12 March 2012

2012/030.L02 CM/sm

INDEPENDENT REVIEW OF SUBMITTED TRAFFIC & PARKING REPORT WITH DUE REGARD TO TRAFFIC, SERVICING & PARKING EFFECTS OF THE PROPOSED ACU STRATHFIELD CAMPUS EXPANSION

Reference is made to your request for an independent review of the traffic & parking report prepared by ARUP dated 14 December 2011 titled "*Australian Catholic University (Strathfield Campus) Transport & Accessibility Study*".

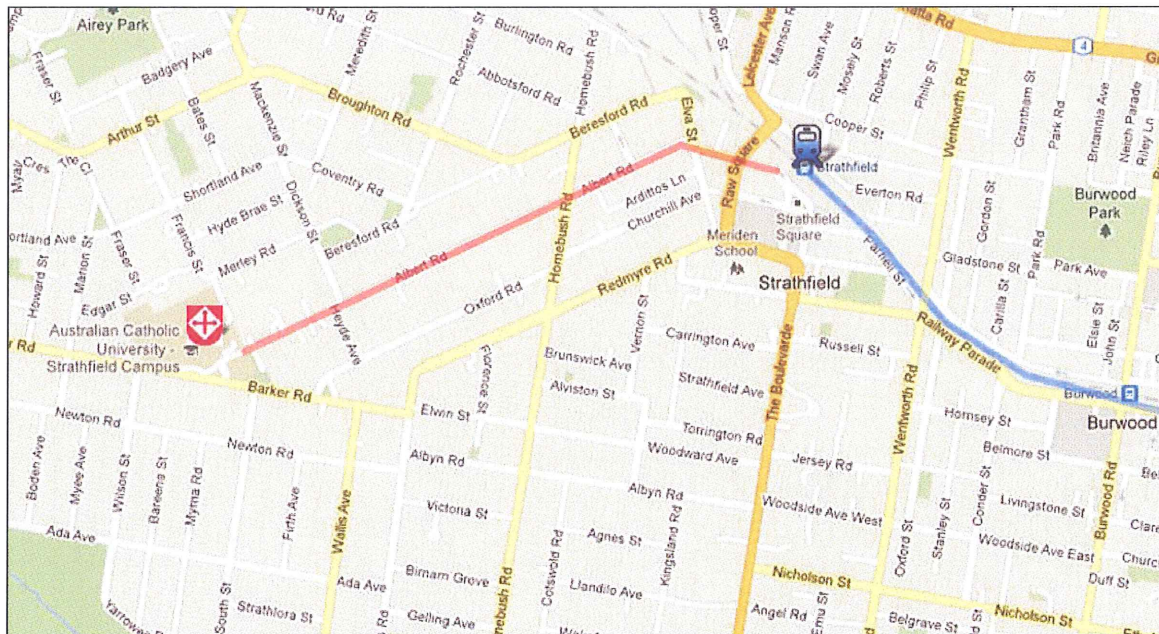
Insufficient detail is provided with respect to current public transport usage rates together with spare capacity of bus services. The statements made in Section 5.5 of the ARUP report are not substantiated. If services are poorly utilised at present it is likely that much greater parking demand will occur with resulting adverse residential amenity impacts in terms of parking demand and peak hourly traffic activity.

The site is located some 1.3km from the nearest train station (Strathfield) and details of scheduled bus route frequency and occupancy levels have not been provide.

The statements that students will be encouraged to travel to and from the site by train, bus, bicycle, car share and walk modes are not supported by details of how that outcome will be achieved and monitored. It is expected that car share schemes would not achieve any significant change in travel mode for students travelling to and from their place of residence.

The site location with respect to proximity to high capacity (train) public transport services is shown below.

Given the long distance from the nearest train station that requires students & staff to use two modes of travel (train & bus) it is expected that higher frequency bus service provision with detailed assessment of bus / rail interchange capacity is required to provide the travel mode shift from car to rail / bus modes. The assessment of bus queuing effects at nearby rail station(s) and at the ACU site needs further detailed investigation.

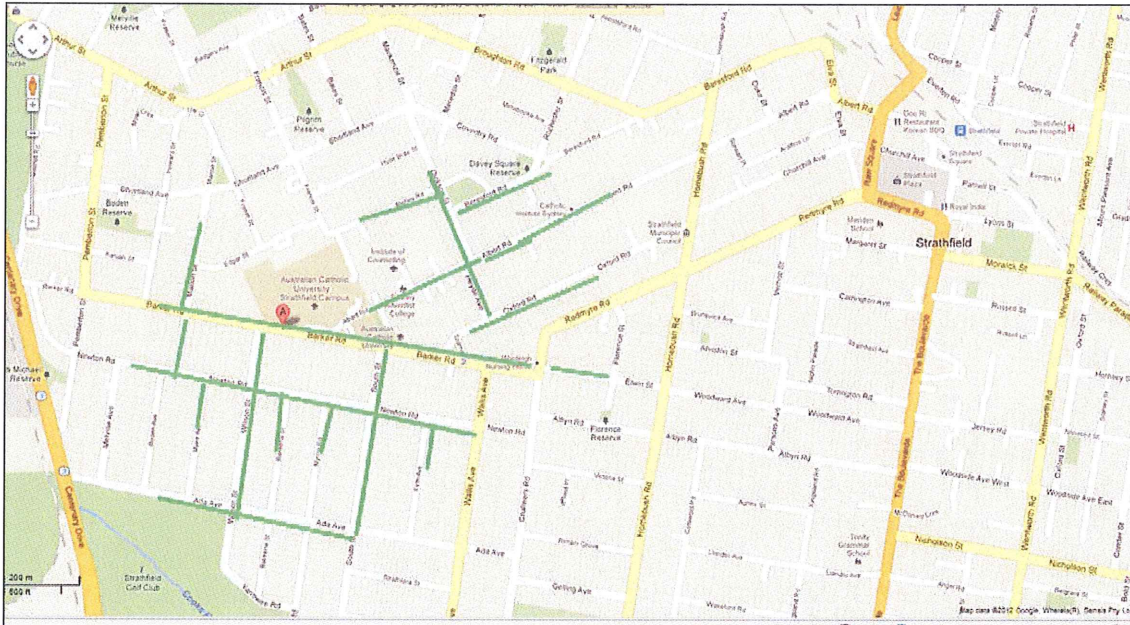
The overspill parking impact assessment undertaken by ARUP is very limited as the surveys reflect a limited road grid to the south and east. The extent of the parking overspill effect is from 10.30 am to 2.30pm and ought to extend to the evening period

to assess impacts at night. It is considered that the surveys need to be undertaken over a wider area, as shown below.

The parking overspill effect identifies some of the sensitive road elements that ought to be assessed in terms of peak hourly activity. There are other sensitive roads that provide access to the overspill parking areas that also need to be gauged (via peak hour flow changes) in terms of residential amenity impacts (both day & night).
